# PERMIT

SEWAGE DISPOSAL SYSTEM  
HOWARD COUNTY HEALTH DEPARTMENT  
BUREAU OF ENVIRONMENTAL HEALTH  
410-313-2640

SUBDIVISION Highland Meadows I LOT NUMBER 18 ADDRESS 13342 Long Leaf Drive

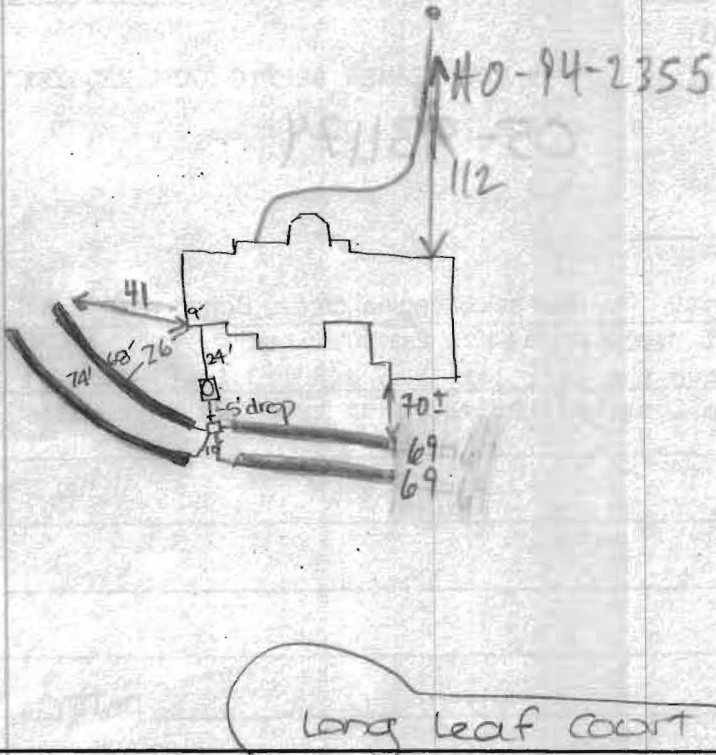
PRE-CONSTRUCTION INSPECTION: Met with builder - He had wrong BP Plan (all elevation from house dam were 2ft lower than on our approval plan; I saw him one crew; He as well only real solution was to move all this stuff, then install septic system (with long leaf dirt, + approval by HOS) then replace fill (up to 8ft deep at downhill side) 4/13/01  
 INSPECTION COMMENTS: \_\_\_\_\_

4/10/01 A.M. septic tank set, house connection made, layout confirmed. DKC

4/10/01 P.M. OK TO COVER 1<sup>st</sup> TWO TRENCHES AND CONTINUE. DKC

4/12/01 OK TO COVER ALL (MR)

4/12/01 WPI ALL OK (MR)
